APPLICATION FOR HOUSEHOLDER PLANNING PERMISSION DELEGATED REPORT

APPLICATION REFERENCE:	PL/2026/02232
APPLICATION TYPE:	Householder planning permission
SITE ADDRESS:	Holmbury, Blandford Road, Coombe Bissett, Salisbury, SP5 4LH
DEVELOPMENT DESCRIPTION:	Proposed First Floor Extension and Alterations
RECOMMENDATION:	That Planning Permission be GRANTED

EXISTING SITE PLAN scale 1:500

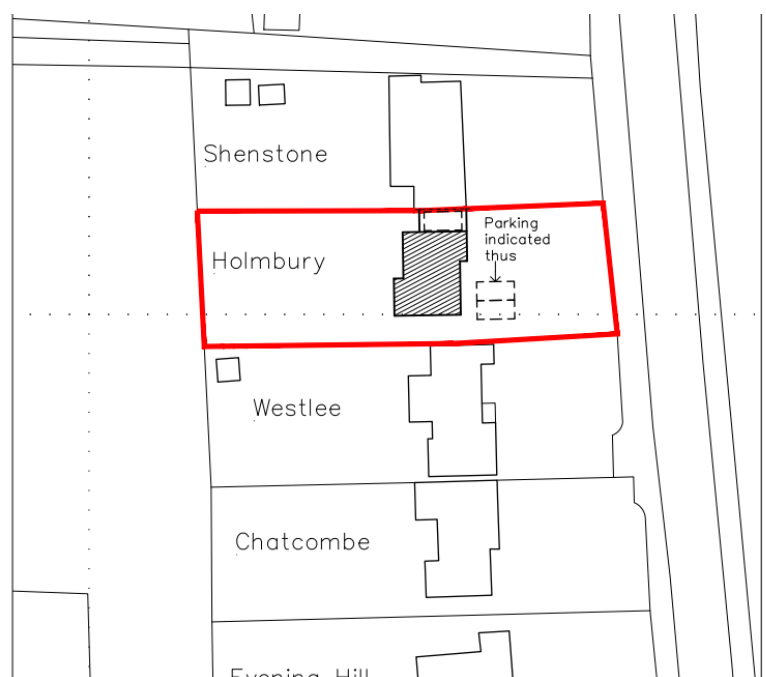
‘The proposal will increase the property from a 2 to a 4 bed dwelling and as such 3 off street parking spaces are required to meet Wiltshire’s current parking standards. Three spaces are shown on the submitted plans with adequate space to make a turning manoeuvre, this situation is existing and not proposed to be altered. I raise no highway objection.’

Wiltshire Council Highways have been consulted on the application and raise no objection. It is noted that the proposal would increase the dwelling from two to four bedrooms, triggering a requirement for three off-street parking spaces in accordance with adopted standards. The submitted plans demonstrate that three parking spaces can be accommodated on site, together with sufficient space to allow for turning, and these arrangements are existing and are not proposed to be altered.

Proposed Street Elevation scale 1:50 ● A1 (1:100 ● A3)

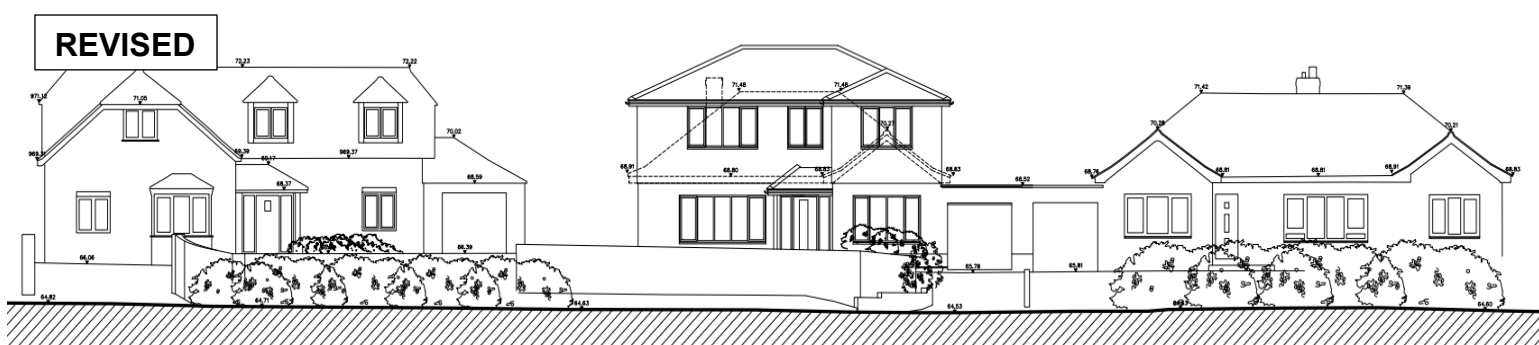
The original submission proposed a substantial hipped roof with significant height and bulk. This raised concerns that the resultant dwelling would exceed the height of neighbouring properties, in particular exceeding the scale of Westlee to the south (a 1.5 storey dwelling) and Shenstone to the north (a single storey bungalow). A street scene drawing was requested and subsequently provided, which confirmed that the originally proposed roof form would result in a development that was appreciably taller than adjacent dwellings, primarily due to the excessive roof height. The dwelling, as originally proposed, would have appeared visually dominant and overly prominent within the street scene, detracting from the established pattern of development.

In addition to concerns relating to scale and massing, the initial design incorporated a full-height stairwell window on the principal (east-facing) elevation and extensive glazing around the entrance. These features were considered overly prominent and at odds with the more modest and restrained fenestration patterns evident on surrounding dwellings. As such, they were identified as harmful to the visual cohesion and character of the street scene.

Following officer feedback, revised plans were submitted which sought to address these concerns. Amendments included a reduction in overall roof height to better align with the scale of Westlee, as well as a simplification and reduction in the extent of glazing on the principal elevation. The stairwell window was reduced in scale and the overall fenestration strategy made more consistent with the established character of the area. These revisions are illustrated in the updated street scene drawing below.

Proposed Street Elevation scale 1:50 ● A1 (1:100 ● A3)

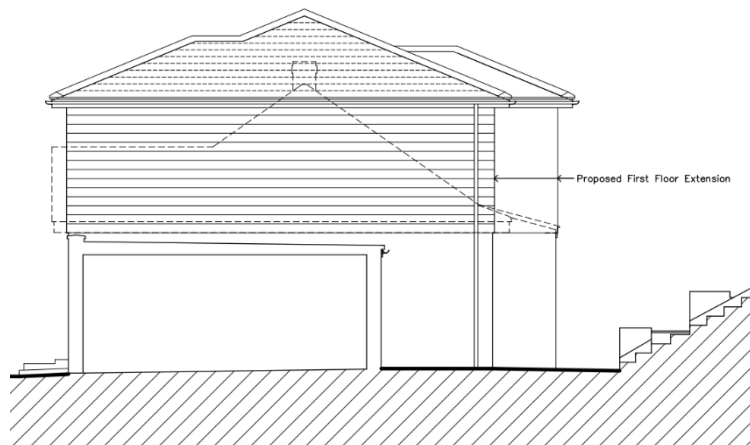
The revised proposals result in a significantly reduced roof height, achieved through a shallower hipped roof form, thereby reducing the overall bulk and visual presence of the dwelling. Whilst the ridge height remains marginally higher than that of Westlee to the south (by approximately 0.5 metres), this difference is limited and not considered to give rise to visual harm.

When viewed in the context of neighbouring properties and the wider street scene, the revised scheme presents as a proportionate and appropriately scaled development. The dwelling would sit comfortably alongside adjacent properties and would reflect the broader mix of built form evident within the locality. The amendments secured through the application process have therefore successfully addressed the initial concerns and have resulted in a form of development that is visually balanced and contextually appropriate.

South Elevation scale 1:50 ● A1 (1:100 ● A3)

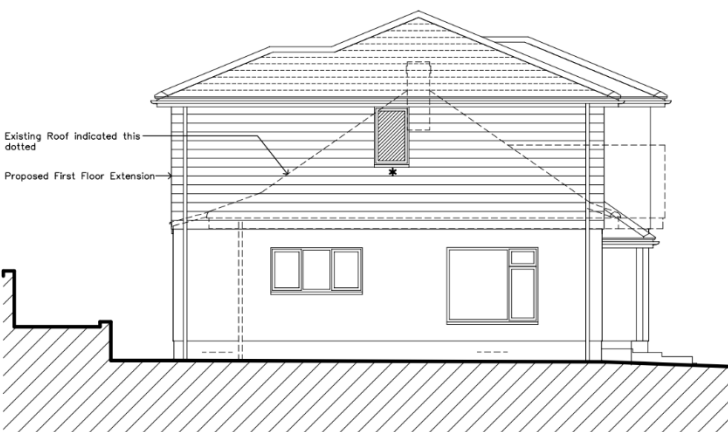
The proposed development includes three first floor windows to the rear elevation, serving two bedrooms and a bathroom. It is acknowledged that these windows would introduce an additional opportunity for overlooking of neighbouring rear gardens. However, these views would be consistent with the established pattern of mutual overlooking within the immediate context and would not result in direct or harmful overlooking of habitable rooms.

With regard to the side elevations, the potential for overlooking has been appropriately mitigated through design. No windows are proposed at first floor level on the north elevation. On the south elevation, a single first floor window is proposed to serve a bathroom, which is shown as obscurely glazed and secured through condition. In addition, permitted development rights for further first floor openings in the side elevations have been removed to ensure that any future alterations can be appropriately controlled.

5. Before the development hereby permitted is first brought into use the windows in the first floor of the west facing rear elevation and the south facing side elevation, serving the bathrooms, as shown on the approved drawing DWG No: (25/0453/102.B) shall be glazed with obscure glass only to an obscurity level of no less than level 5 and shall be maintained with obscure glazing for the lifetime of the development.
